Project	IEEE 802.16 Broadband Wireless Access Working Group < http://ieee802.org/16 >	
Title	DL channel sounding based on relaying the received downlink pilot at UL	
Date Submitted	2005-01-23	
Source:	Wen Tong, Jianglei Ma, Ming Jia, Peiyong Zhu, Mo-Han Fong, Hang Zhang and Brian Johnson	Voice: (613)-763-1315 Fax: (613)-765-7723 wentong@nortelnetworks.com
	Nortel Networks 3500 Carling Avenue Ottawa, ON. K2H 8E9 CANADA	
Re:	IEEE 802.16-REVe/D5a, BRC recirc	
Abstract	DL channel sounding based on relaying the received downlink pilot at UL	
Purpose	To incorporate the changes here proposed into the 802.16e/D5a draft. The update is in blue font	
Notice	This document has been prepared to assist IEEE 802.16. It is offered as a basis for discussion and is not binding on the contributing individual(s) or organization(s). The material in this document is subject to change in form and content after further study. The contributor(s) reserve(s) the right to add, amend or withdraw material contained herein.

DL channel sounding based on relaying the received downlink pilot at UL

Figure 1 Joint CSIT pilot and transponder pilot channel sounding for FDD

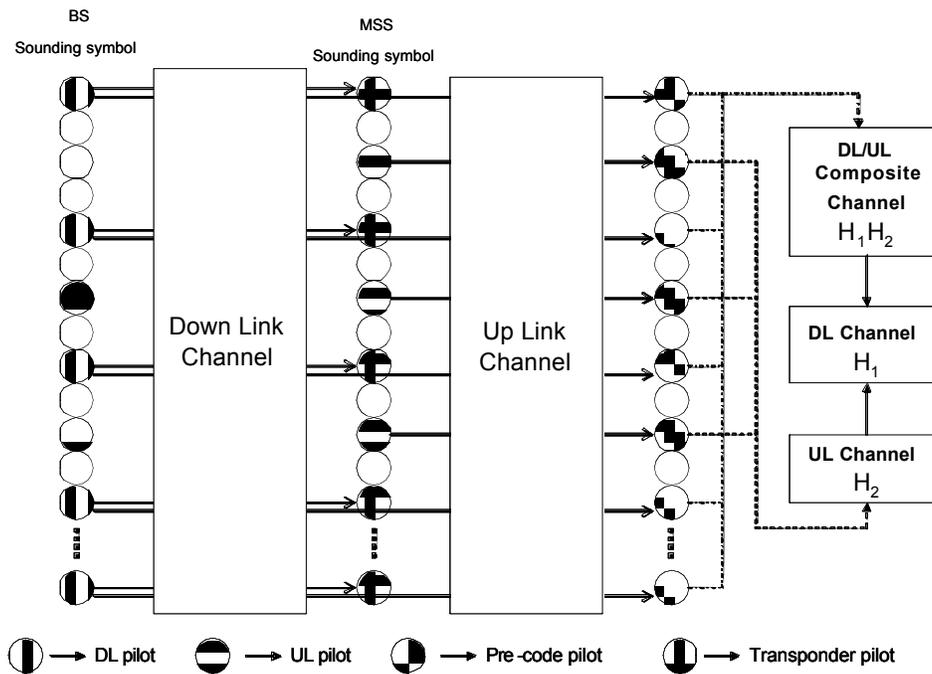
This contribution provides a modification to the uplink channel sounding proposed in [1]. The advantage of this approach is to allow BS to estimation the down link wide band channel response in the FDD operation. In [1] after the DL channel is estimated. And then the estimation channel is modulate on the UL sounding pilot to assist BS to further estimate DL channel to perform beam-forming. In this contribution, we propose to use the existing .16e DL and UL pilot constructs to achieve the same object in a more efficient fashion. In Figure 1, the DL sounding symbols (decimate in frequency domain) are received by MSS modem, the MSS applies the received soft sample of received pilot as UL sounding symbol (to replace the CSIT sounding symbol as a transponder pilot), in addition, the MSS also transmission the CSIT sounding pilot. Figure 1 also demonstrates an example how BS can use the transponder pilot and CSIT pilot to estimate both UL channel and L channel.
